State of California
The Resources Agency
DEPARTMENT OF WATER RESOURCES
DIVISION OF SAFETY OF DAMS

INSPECTION OF DAM AND RESERVOIR IN CERTIFIED STATUS

Name of dam Oroville Dam Dam No. 1-48 County Butte
Type of dam Earthfill Type of Spillway Gated Concrete Weir and Chute
Water is 114.32 feet below spillway crest and 222.52 feet below dam crest.
W.S. 699.48 feet
Weather Conditions Partly cloudy and cold
Contacts made Alex Samaan, OFD; David Panec and Mike Urbano, O&M.
Reason for inspection Periodic Evaluation (1st inspection)

1. This picture shows the spalling at the left abutment of the spillway bridge deck. Conditions at the right abutment are similar. Fresh paint has been sprayed on the spalled areas in order to track the progress of deterioration. Photograph courtesy David Panec, O&M.

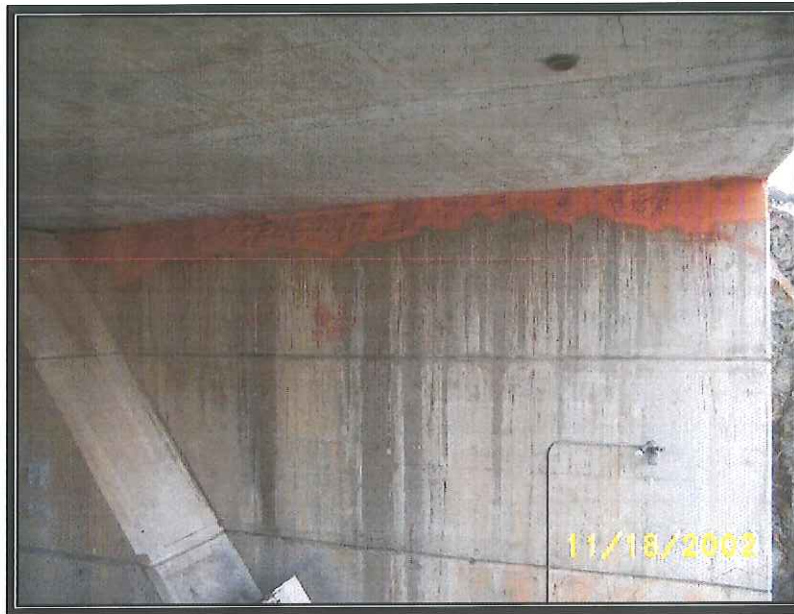
The radial gate repairs have been completed. In addition, one trunnion pin was removed for inspection and found to be in satisfactory condition. Concrete spalling continues at the left and right abutments of the spillway boat ramp access bridge. The field office is monitoring the displaced riprap on the upstream slope of the dam as requested during the last inspection. O&M is reviewing the instrument program, and has contracted with DOE to develop a new PMF.
